Unit BC - Progress Meeting Notes

MEMO TO - Unit BC File
MEMO BY - Dick Carlson
SUBJECT - Unit BC Progress Meeting
DATE - February 4, 1976

**UNIV. OF MINN.
HEALTH SCIENCE
PLANNING OFFICE**

EXAM ROOM TYPE E-1 SHOWN, TYPES E2, E3, E4, E5, E10, E11, E20, E21, E22, E23, E24 ARE TYPICAL.

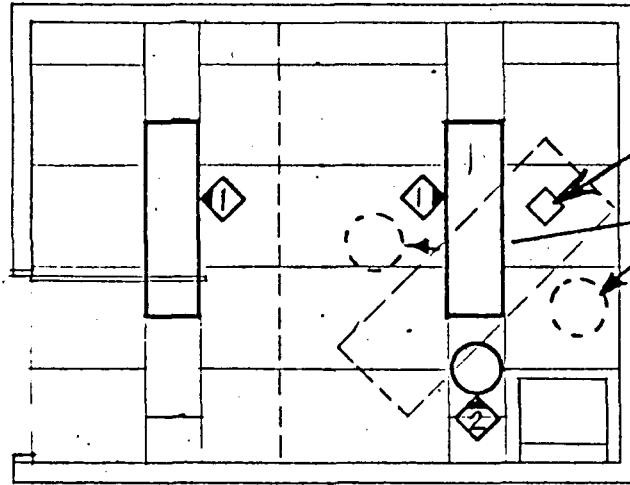
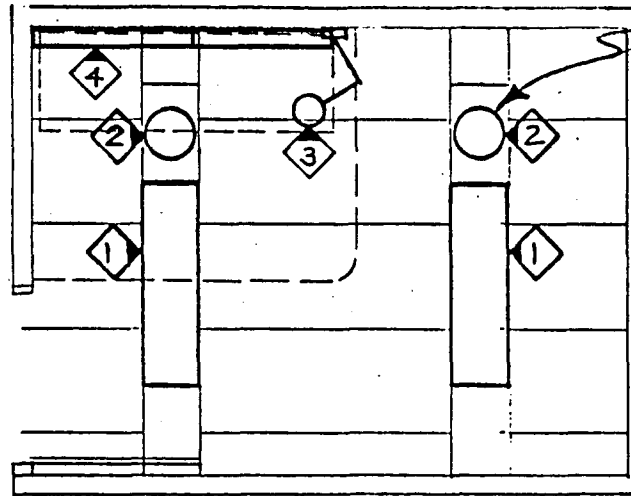
Sheet 2, Exam Rooms E-1, 75 rooms (\$180.00) = \$13,500.00.

Sheet 3, Exam Rooms E-1, (Alternate Tungston Halogen fixture) 75 rooms (\$200.00) = \$15000.00.

Dickler reported that 100 foot candles is required over entire surface of the exam table. Kujawa will investigate the appropriate light level for P.A.R. The Hospital will resolve the funding of this revision with the Planning Office so that a directive can be given the Architect.

EXAM ROOM TYPE E-8, TYPES E6, E7, E9, E12, E13, E14, E15, E16
E17, E18, E19, ARE TYPICAL.

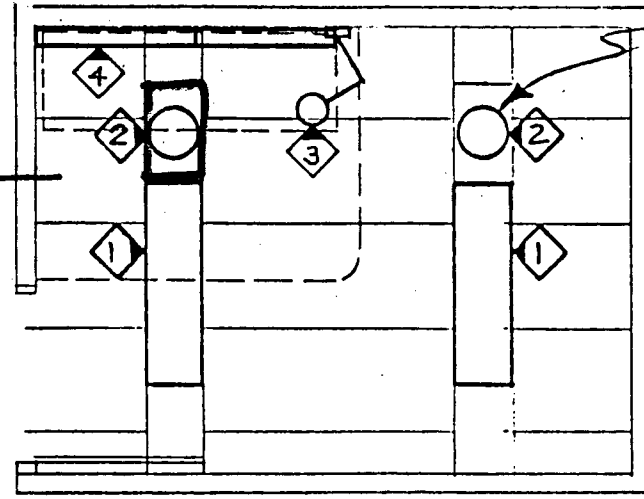
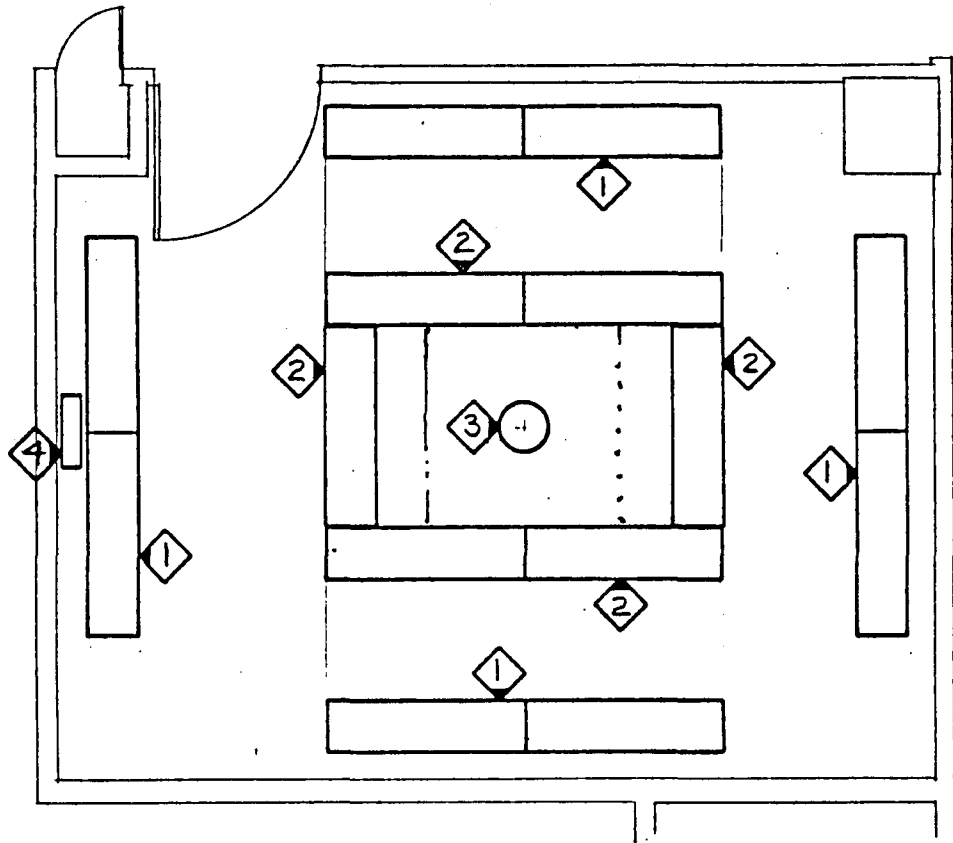
Sheet 1, Exam Rooms E-8, 32 rooms (\$220.00) = \$7040.00.

Sheet 4, Minor O.R., 3 rooms (\$220.00) = \$660.00.
